RE: Explanation of Significant Differences
Refined Metals Corporation
3700 South Arlington Avenue
Beech Grove, Indiana
IND 000 718 130

EXPLANATION OF SIGNIFICANT DIFFERENCE

REFINED METALS CORPORATION

BEECH GROVE, INDIANA

PROPOSED CONDITIONS DRAINAGE AREA PLAN

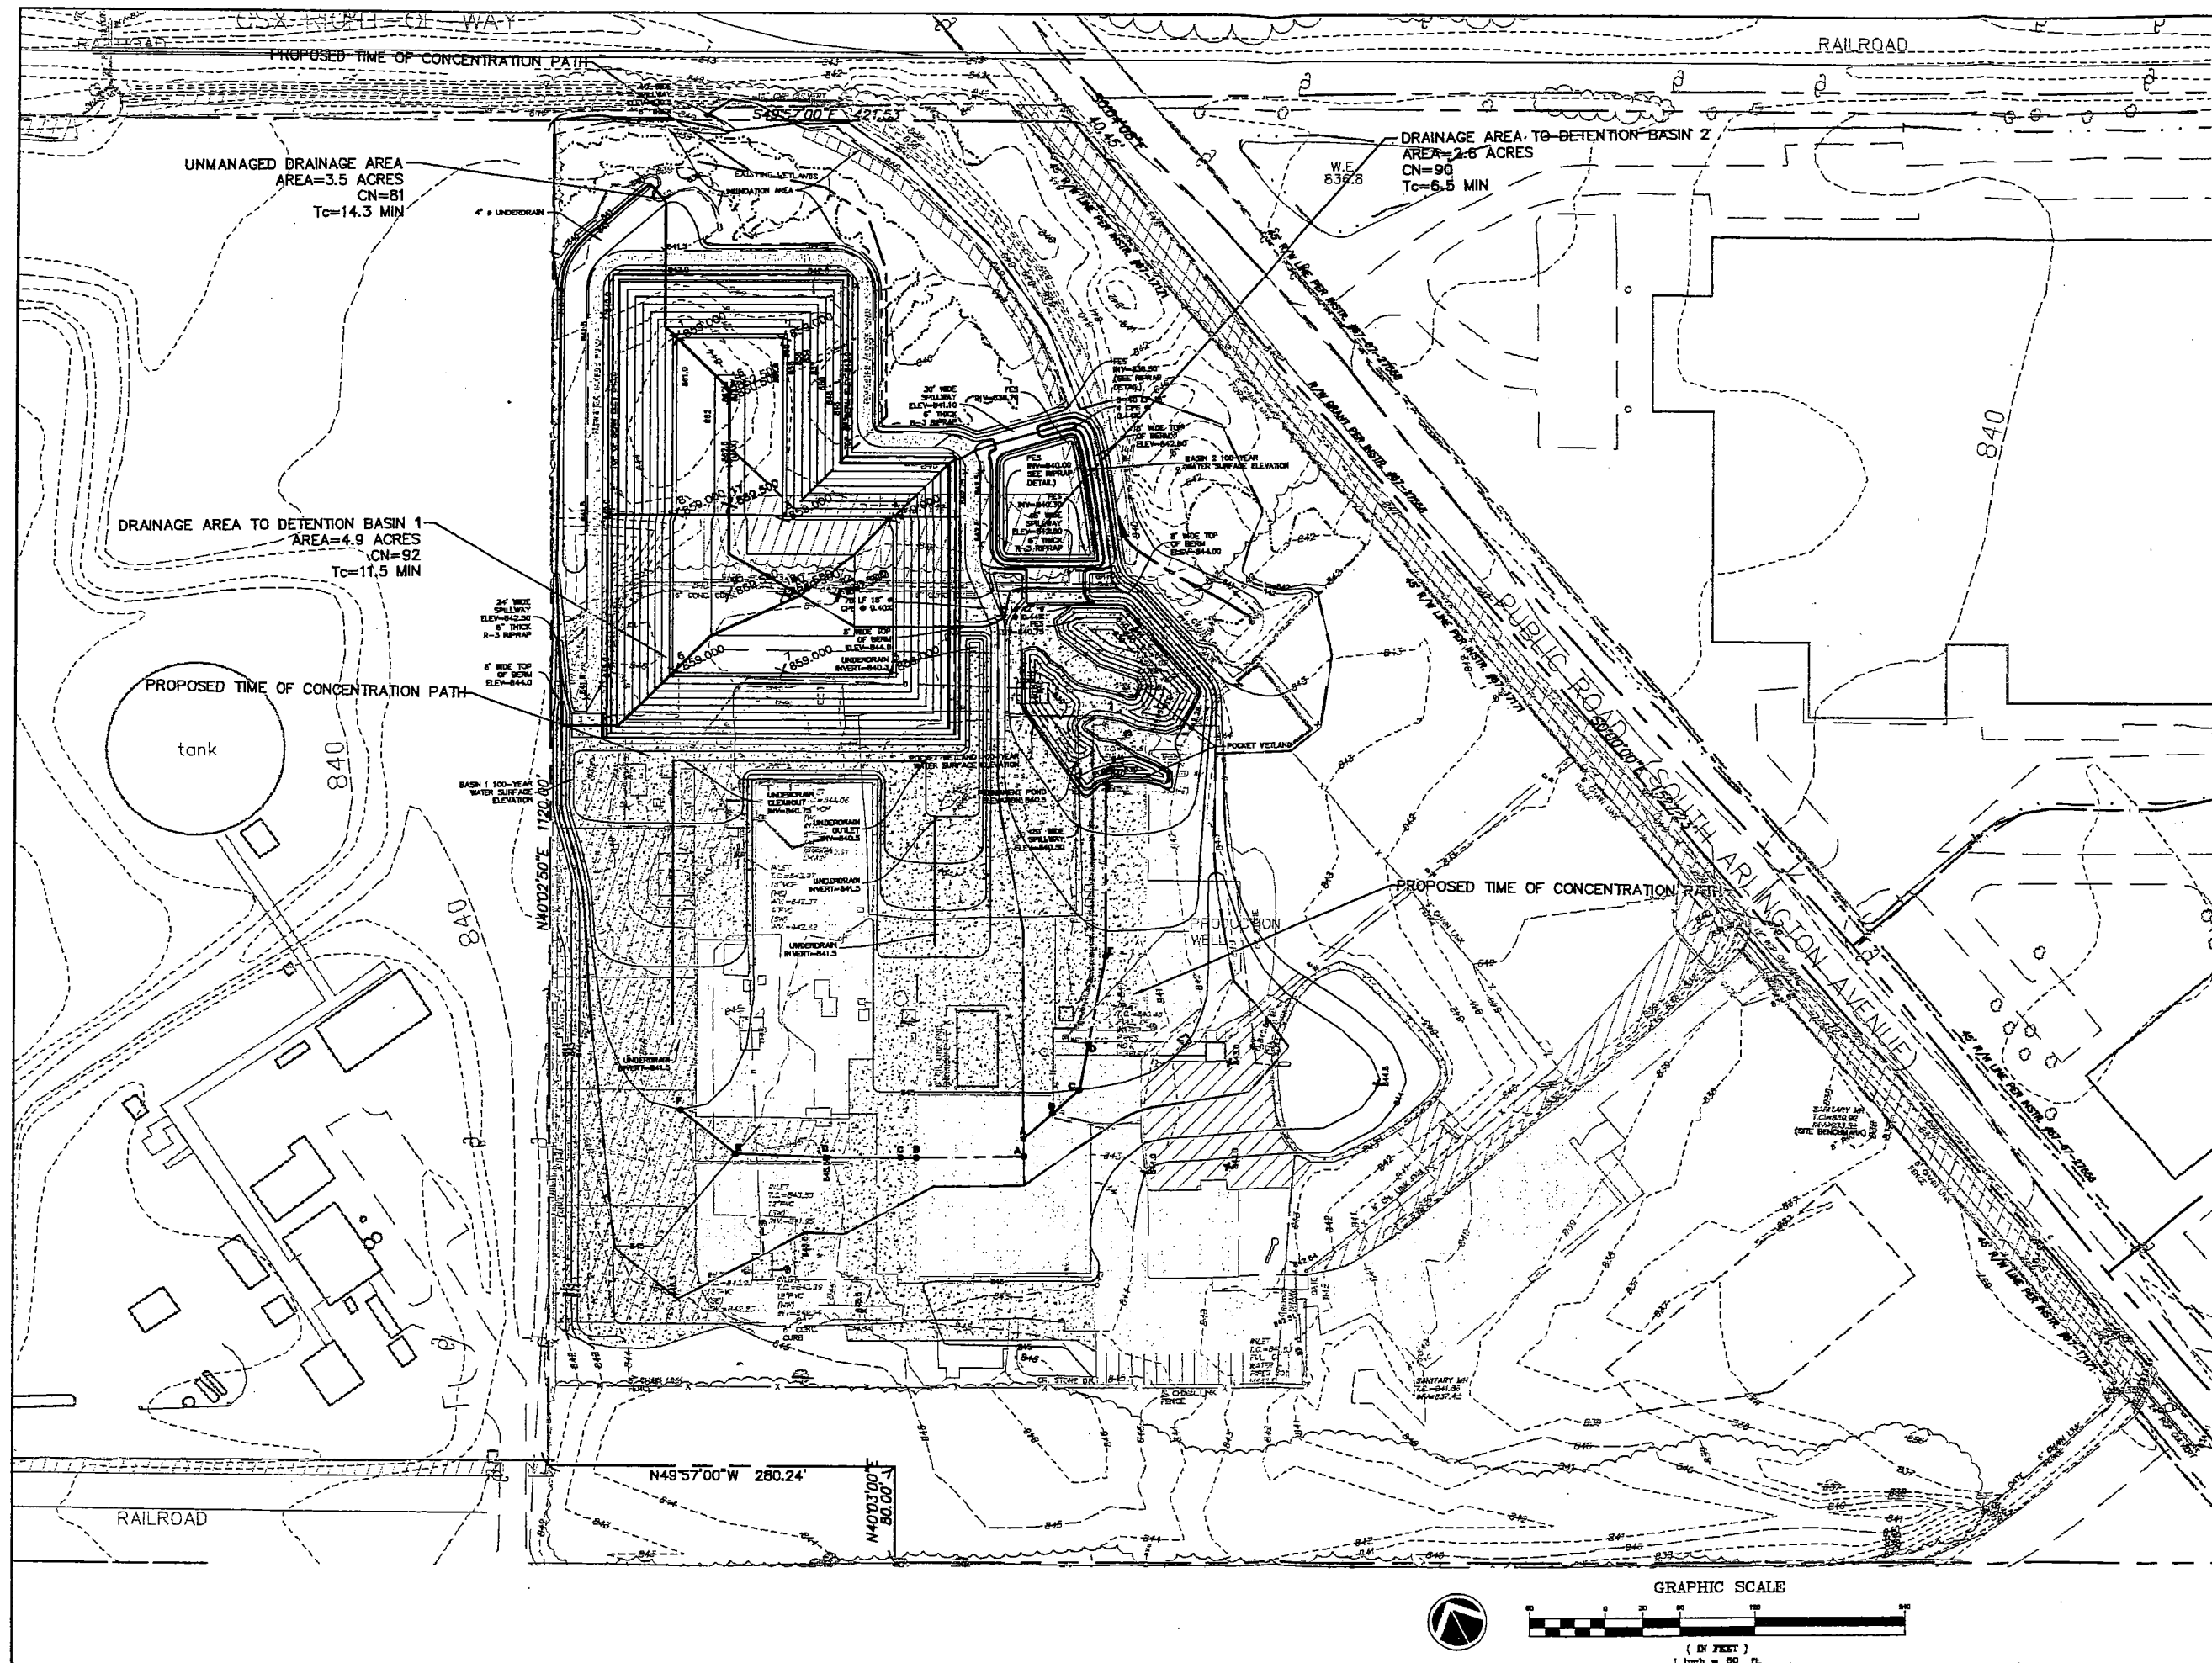
DATE	REVISION
06-30-11	REV. PER 06-20-11 INDIANAPOLIS REVIEW LETTER
08-04-11	REV. TO FINAL
11-20-12	REVISE CAP LAYOUT
6-12-13	REVISE STORMWATER MANAGEMENT BMP'S
7-18-13	REV. PER 06-27-13 INDIANAPOLIS REVIEW LETTER
2-12-14	REV. PER 1-16-14 EPA REVIEW LETTER
